DEVELOPMENT APPLICATIONS

1 31 Campbell Street, Eastwood - Demolition, new dual occupancy (attached) and strata subdivision - LDA2020/0139

Report dated: 07 October 2020

City of Ryde Local Planning Panel Report

Figure 12 - Proposed amended Ground Floor Plan

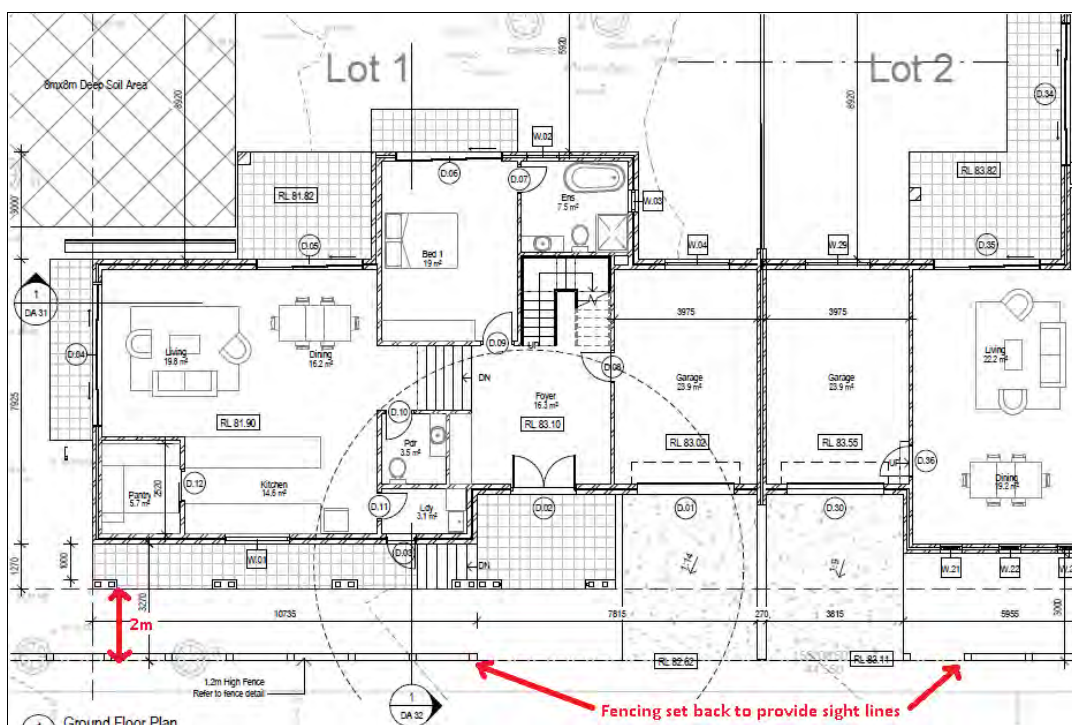
Amended architectural plans and stormwater plans were lodged with Council on 31 August 2020 detailing the following amendments:

- Relocation of on-site detention system under the proposed driveway;
- Increased secondary front setback to 2 metres from Wentworth Road;
- Fencing set back from the driveway to provide for vehicle sight lines.

Figure 13 - Setback from the Front Boundary to the Facade and Terrace

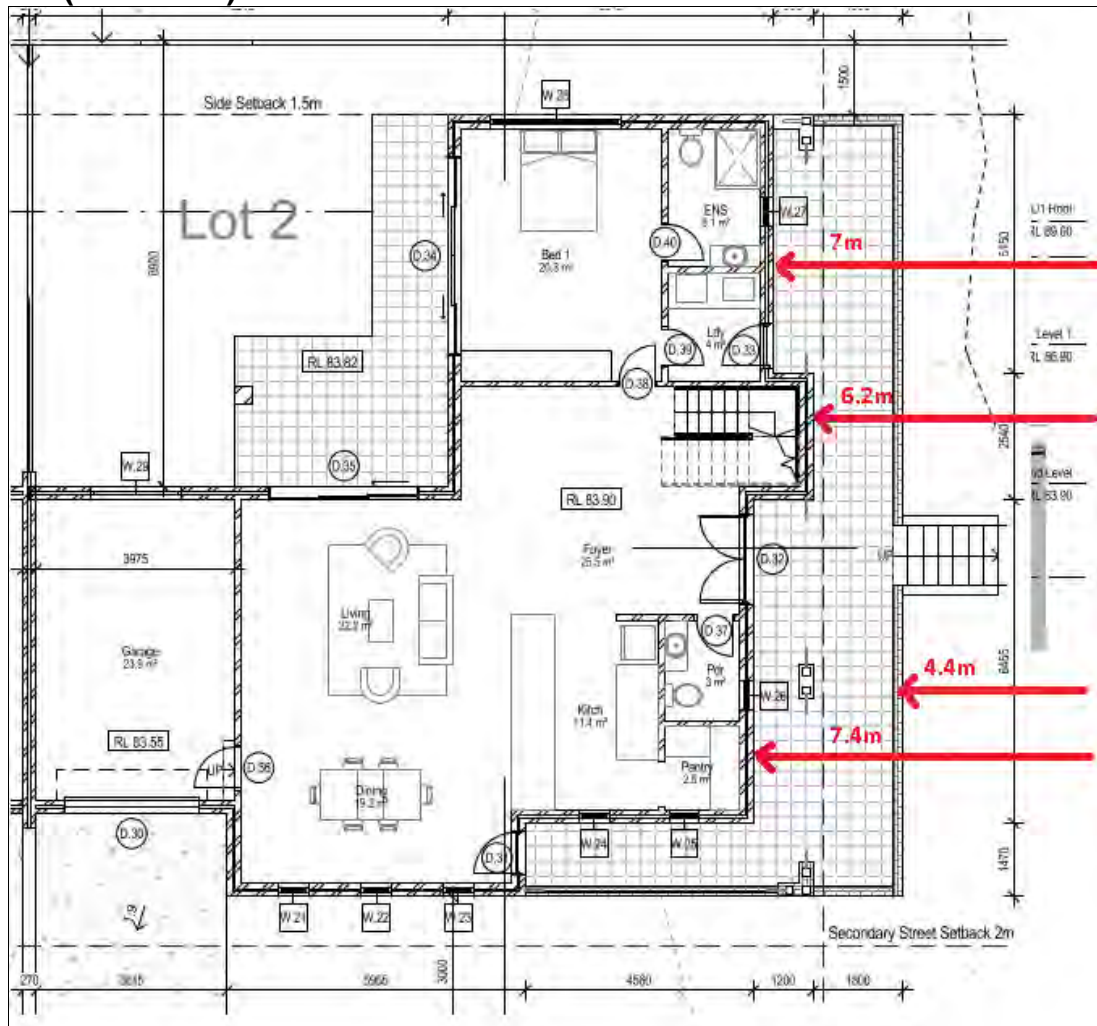
Control 2.9.1(b) requires a 2 metre setback to the secondary street. The plans submitted with the application detailed a setback of 1.73 metres from Wentworth Road frontage to the outside face of the elevated front porch and first floor balcony of the proposed Lot 1 dwelling. A request for further information was forwarded to the applicant requesting compliance with the minimum 2 metres setback control and amended plans were submitted increasing the setback to 2 metres to achieve compliance.

The objectives of the control seek to provide suitable front gardens and consistent building setbacks along streets. The built form that would be visible from the public domain is set back a minimum of 6 metres and is generally consistent with the setbacks of neighbouring properties on the low side of Campbell Street. Substantial landscaping including canopy trees and hedges is provided within the front garden and the building is sited suitably on the allotment to minimise any amenity impacts upon neighbouring properties and the streetscape. The numerical non-compliance is considered to be acceptable given that the terrace area would not be visually prominent and the objectives of the control are achieved.

Figure 14 - Potential building footprint - DCP minimum setbacks indicated in red

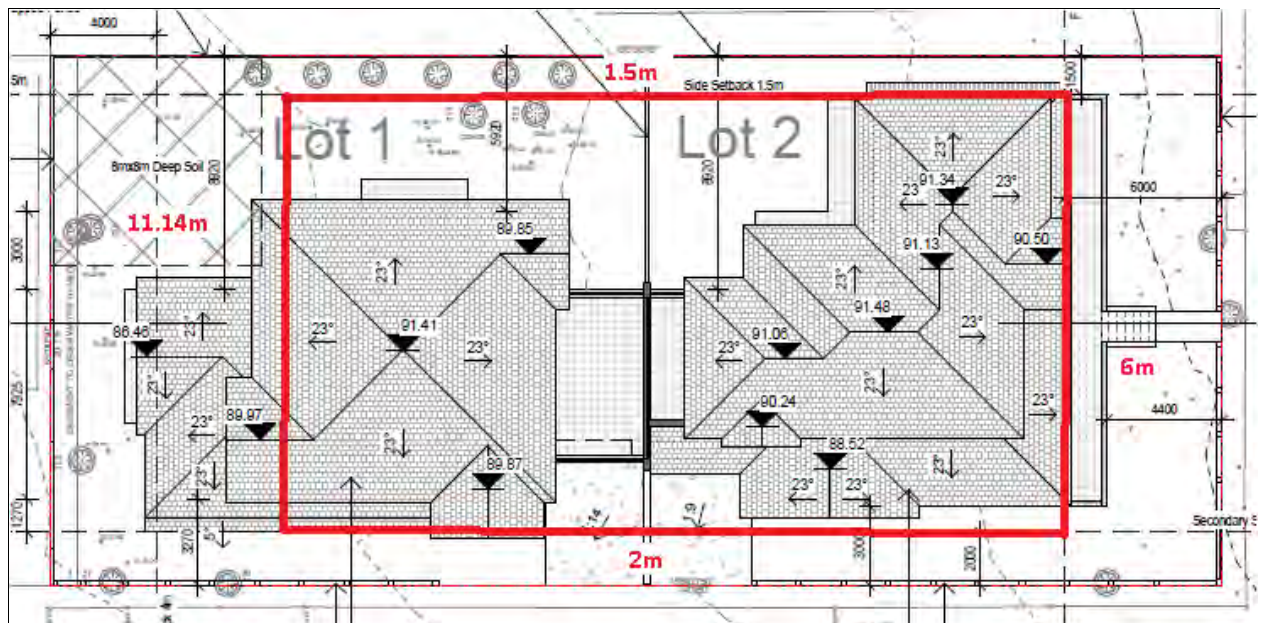
The objectives of the control seek to provide for areas of private outdoor recreation, vegetation and privacy. The proposed development results in a significant numerical non-compliance to the rear boundary, however substantial setbacks are provided to the eastern side boundary which allows for suitable private open space and solar access to both proposed dwellings, as well as the neighbouring property at 29 Campbell Street. The proposed eastern side setbacks result in less built form in close proximity to the dwelling at 29 Campbell Street, providing for visual privacy between

Figure 15 - 8m x 8m Deep Soil Area

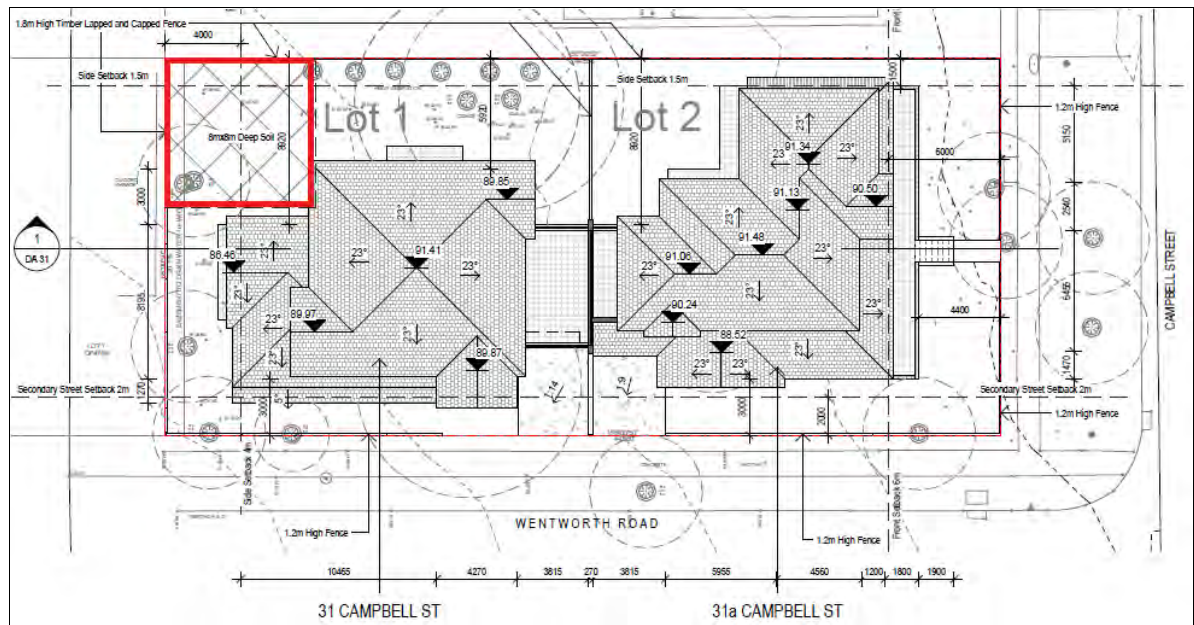
dwellings. An 8m x 8m deep soil zone is provided at the north-east corner (**Figure 15**) of the site, allowing for the provision of substantial landscaping.

The neighbouring dwelling to the rear at 56 Rutledge Street would not experience any significant loss of amenity as their garage and existing landscaping provide a visual barrier between the subject site and their main private open space area. The proposal achieves the objectives of the control, therefore the non-compliance is considered to be acceptable.

Figure 11: Section showing the two height line and the variation to the 19m height by the lift over and stairwell outlined in orange.

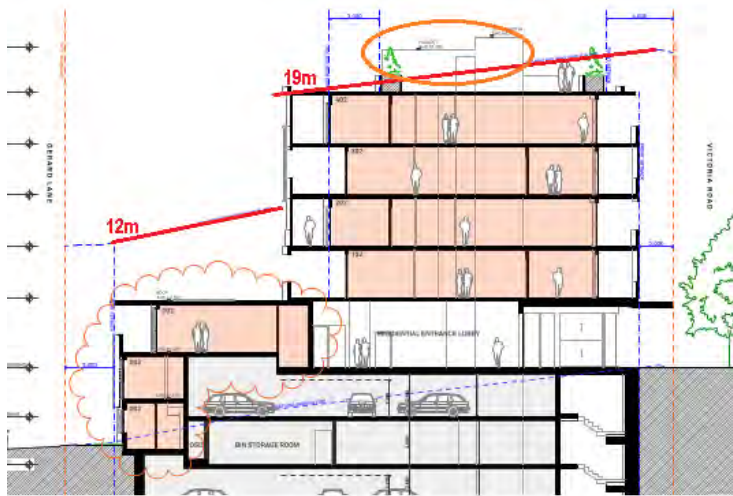
The proposal provides a communal open space area on the roof with lift access. The proposal will result in a maximum building height(s) of:

Figure 12: Illustrate the height plane and the extent of non-compliance in pink, first diagram is from Victoria Road and the 2nd is as viewed from Gerard Lane with the 12m height plan.

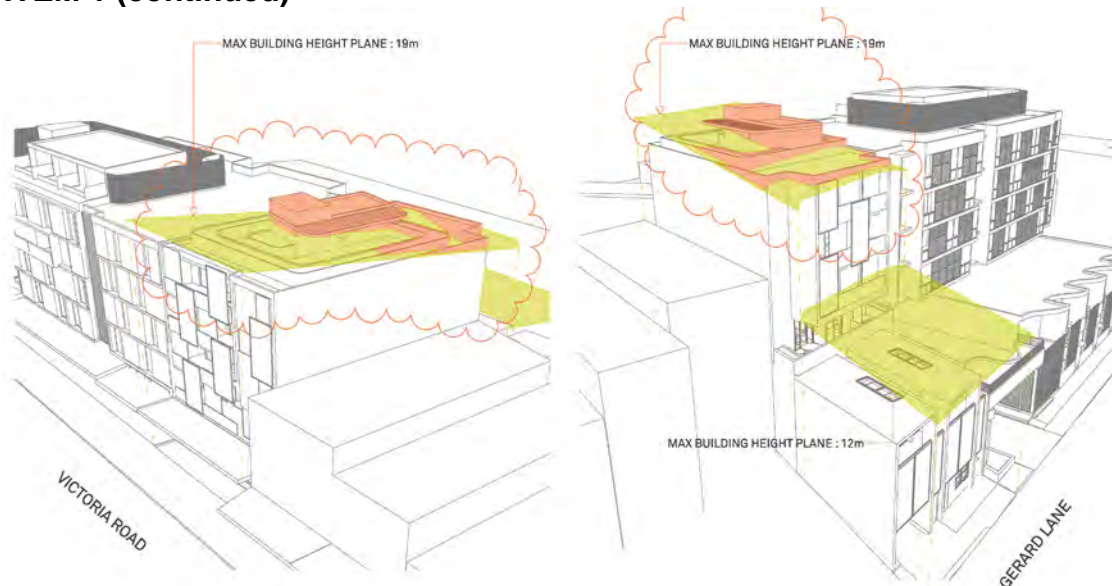
Accordingly, the applicant has submitted a written request seeking to justify the variation to the development standard contained in Clause 4.3. A Clause 4.6 statement accompanied the amended plans received on 6 August 2020, **Attachment 3**.

Figure 14: Overshadowing by the lift over run, between the hours of 9.00am to 11.00am

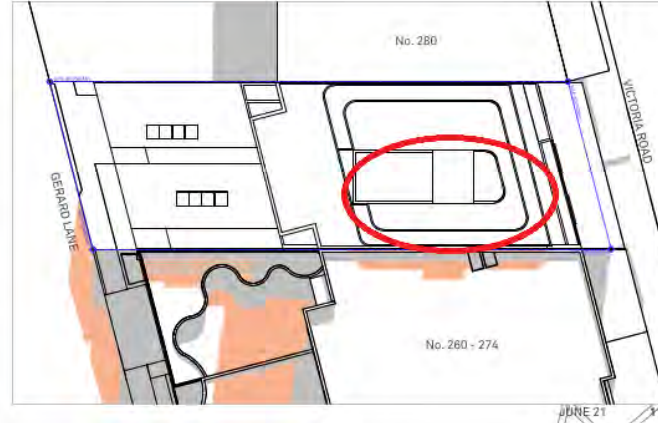
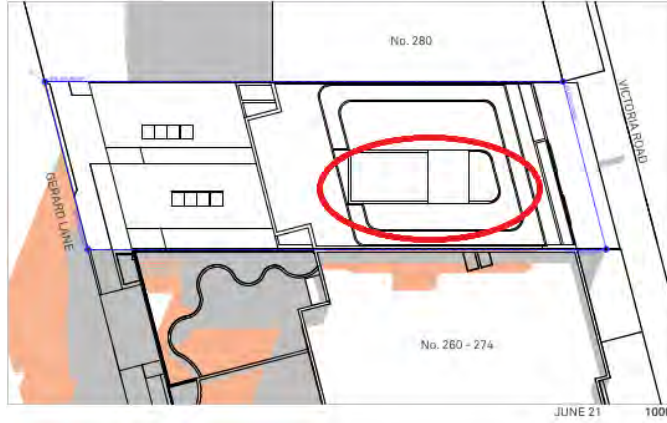
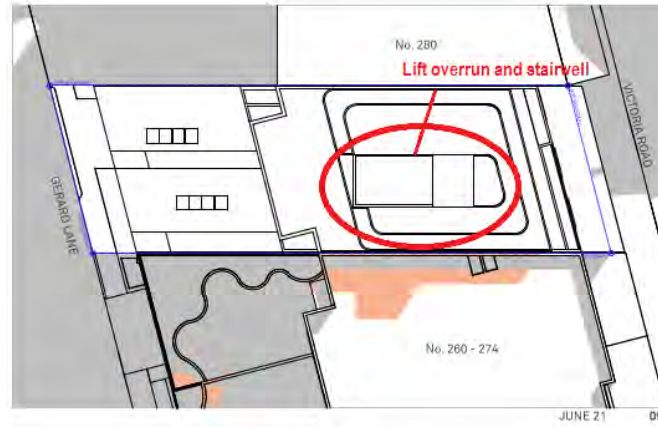
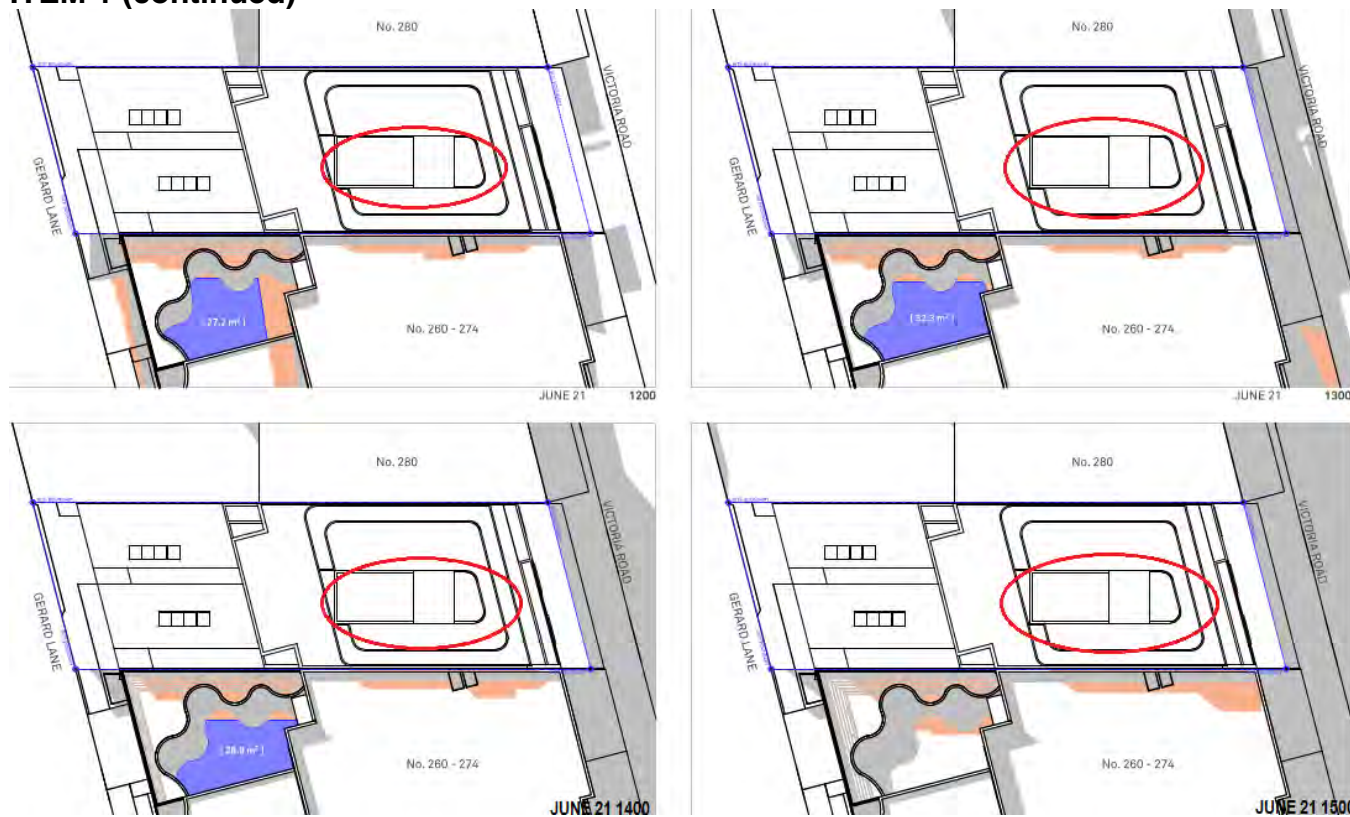
COMMUNAL OPEN SPACE ON No. 260-274 RECEIVES 2 HOURS OF DIRECT SUNLIGHT TO AT LEAST
50% OF ITS PRINCIPAL USABLE PART, BETWEEN 12pm TO 2pm

Overall, the development provides a better planning outcome for this particular site and also the surrounding area in terms of streetscape, rhythm of development and visual fit based on the particular urban collective in which it is located.

Figure 17: Section plan of site showing rear setbacks to Gerard Lane

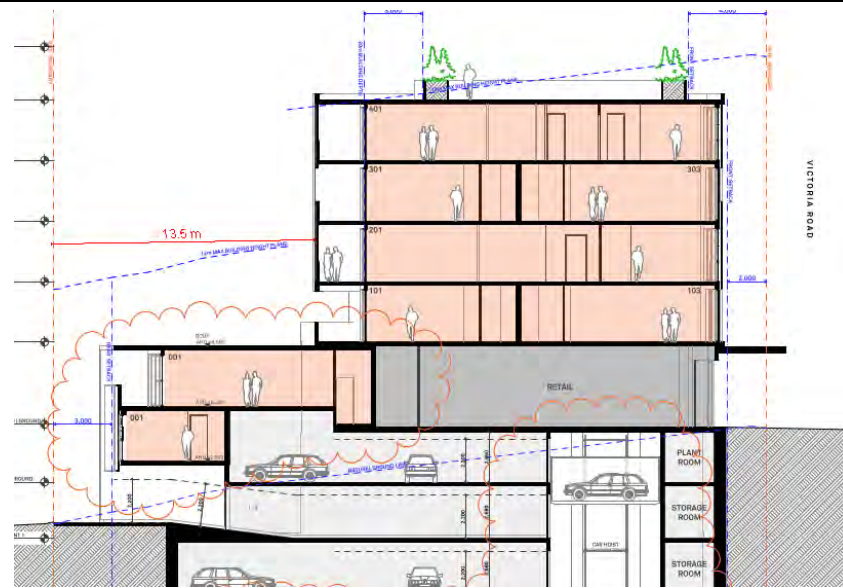
The proposal provides a 3m clear setback from Level B1, lower ground and ground level, as shown below at **Figure 17**.

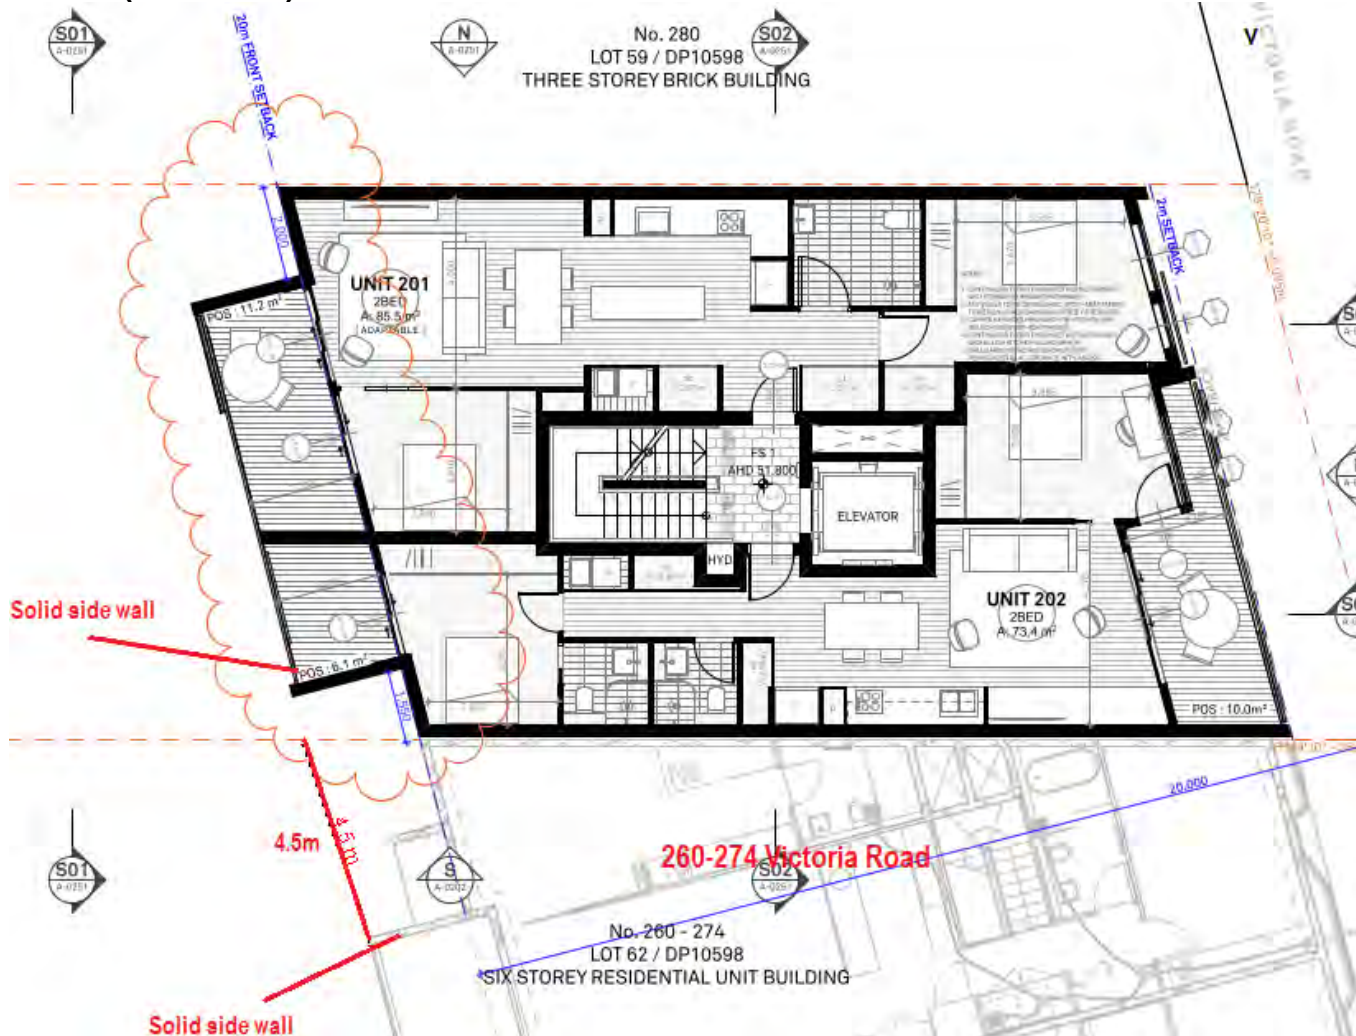
<p>existing building was only two storey and there was considered to be no visible impact. Given the narrowness of the site, it is not possible to provide the required 6m setback. The applicant sought to address the issue of overlooking by provision of a solid cladding wall along the side elevations of the balconies thereby preventing overlooking into the side properties. 260 Victoria Road has also applied this mitigation treatment (solid cladding along the side of their balconies which extend beyond the 20m depth), see Figure 18. Accordingly overlooking from these balconies is not considered to be an issue.</p> <p>It should be noted that this development is designed by the same architect as 260 – 274 Victoria Road, who has designed this proposal to be in line and consistent with 260 Victoria Road.</p> <p>Residential use has been incorporated at the rear of the site opposite the lower density residential area.</p>	<p>Yes</p>
